**August 9, 2011
Medway Planning and Economic Development Board Meeting
155 Village Street
Medway, MA**

Village Estates Definitive Subdivision Plan – 272 Village Street:

Re: Village Estates Definitive Subdivision Plan

PRELIMINARY SUBDIVISION PLAN
 "BAY OAKS"
 MEDWAY, MASSACHUSETTS

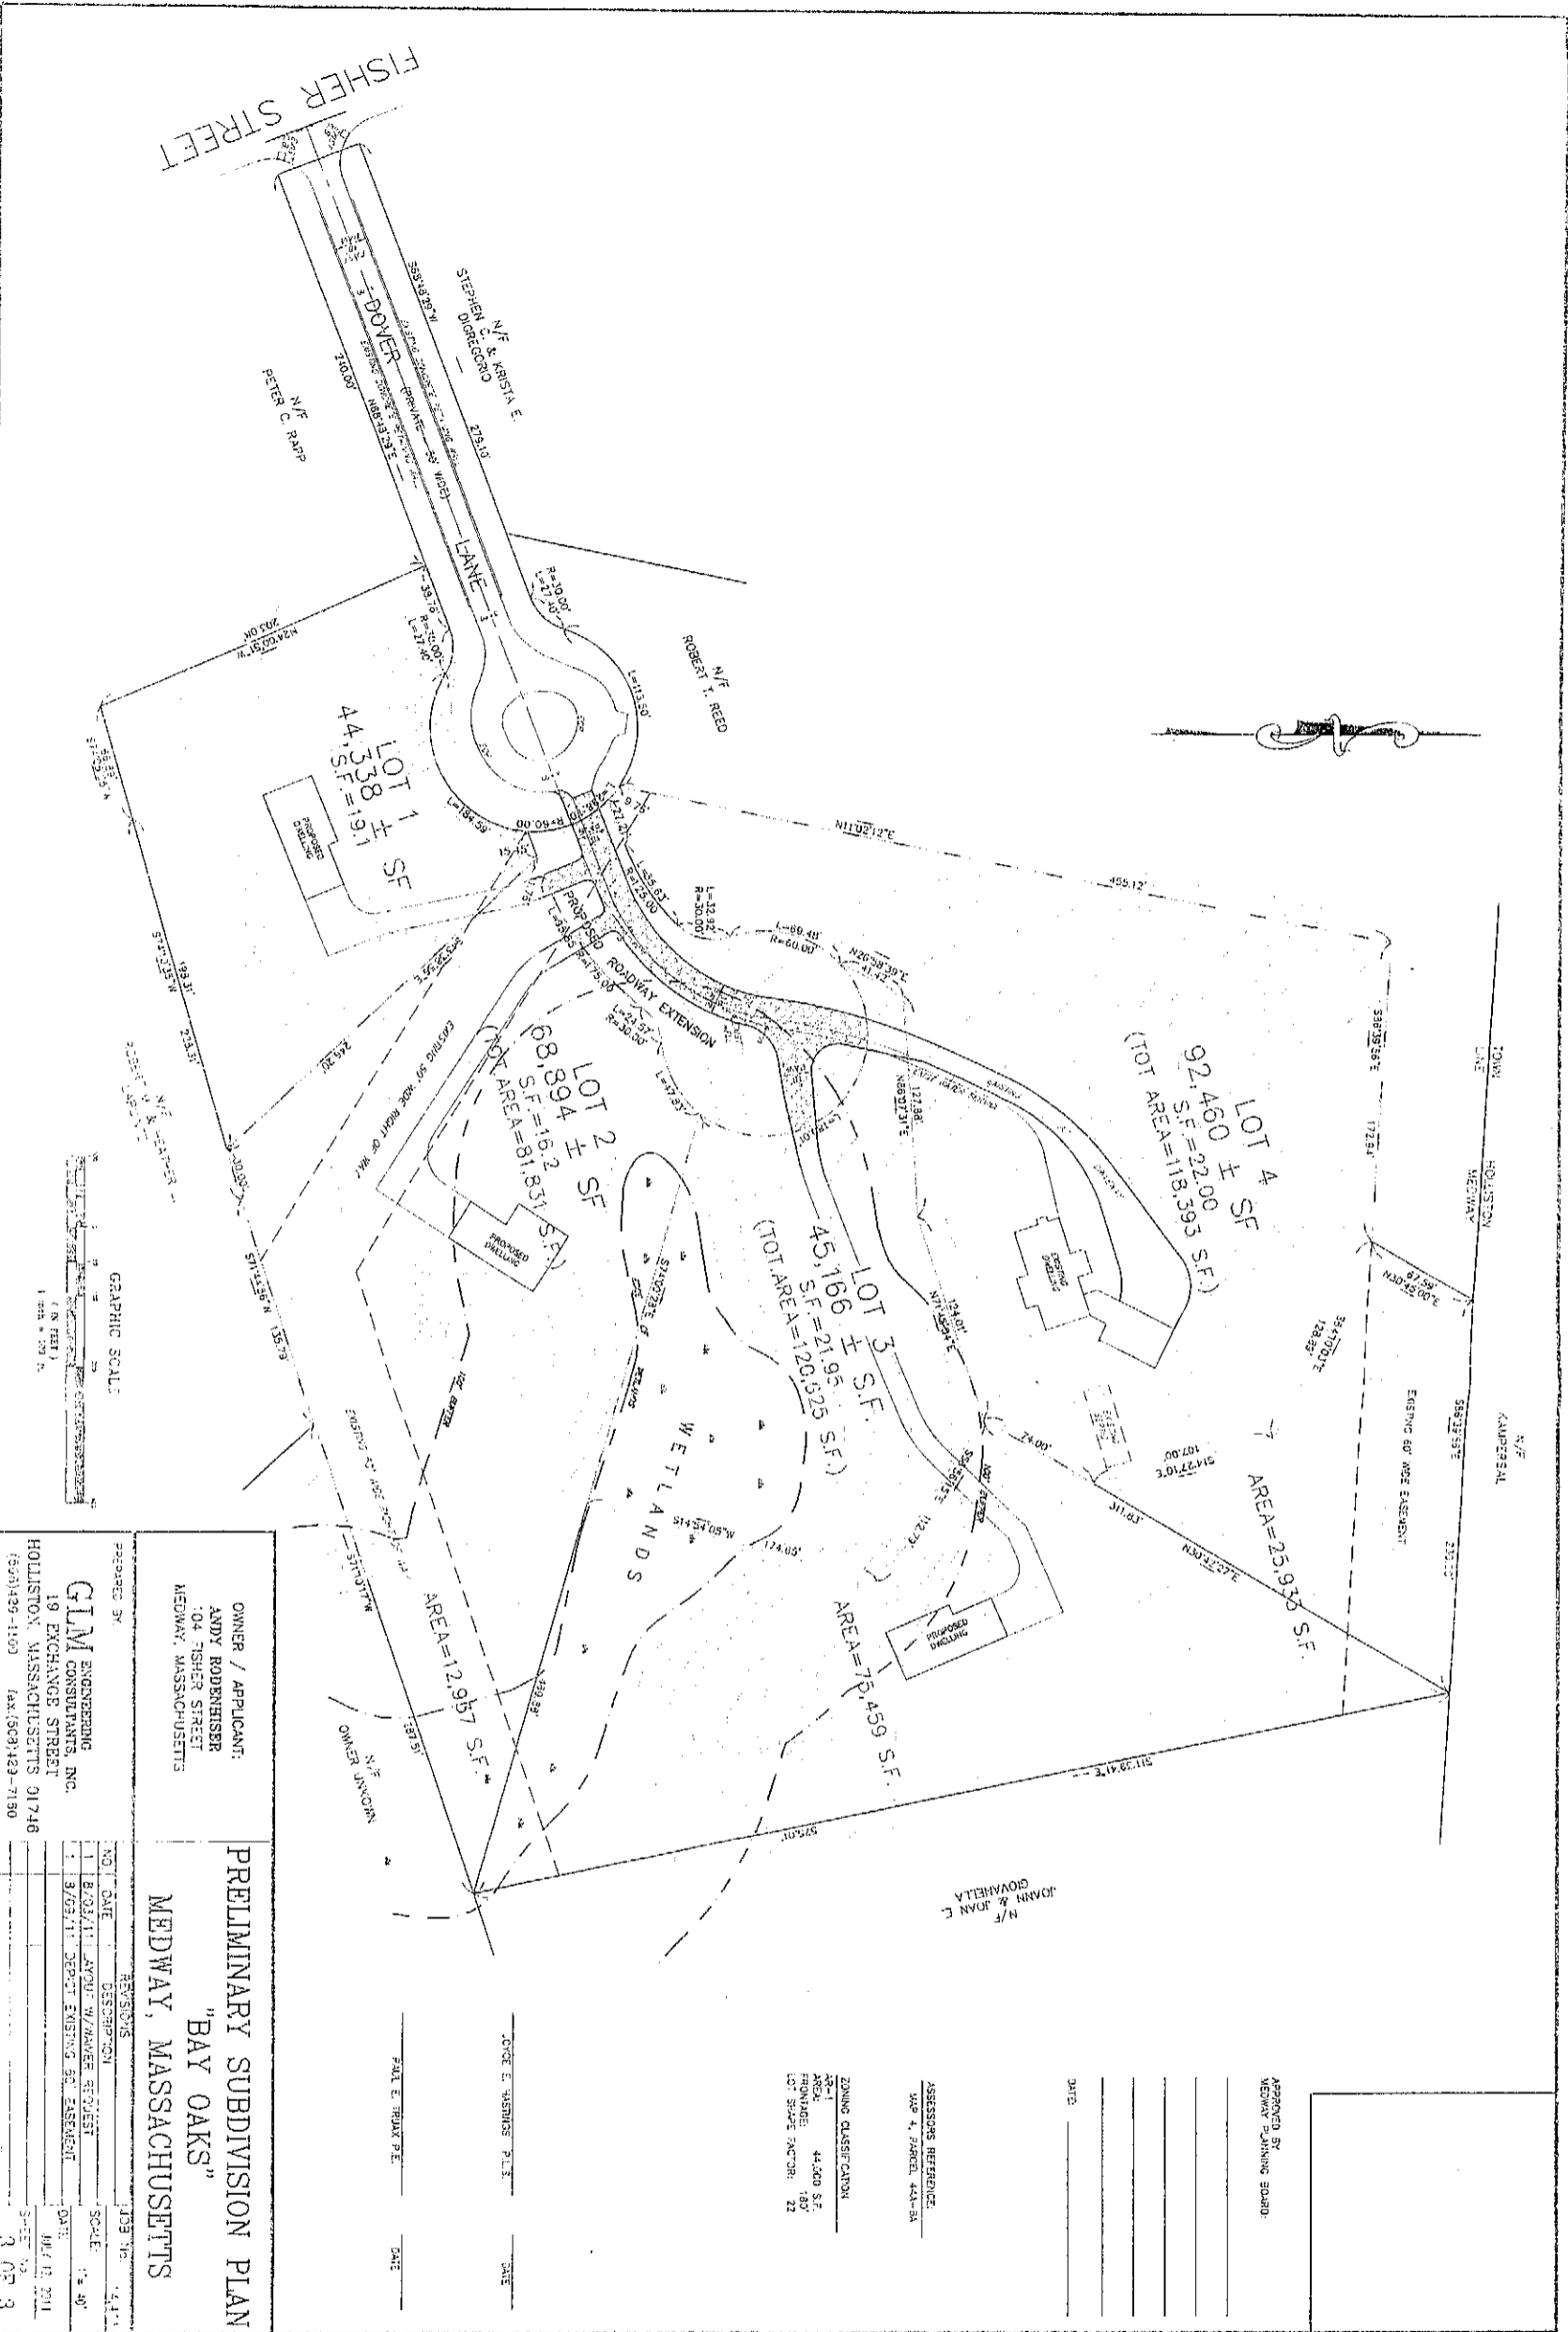
Member Tucker asked that when they go to revise the plans again, to please add a note about the 50 foot easement running all the way to Fisher Street. Please note that this does exist and is not a dead end at the cul-de-sac. The applicant will also need an easement for the driveway on Lot one to cross the adjacent lot.
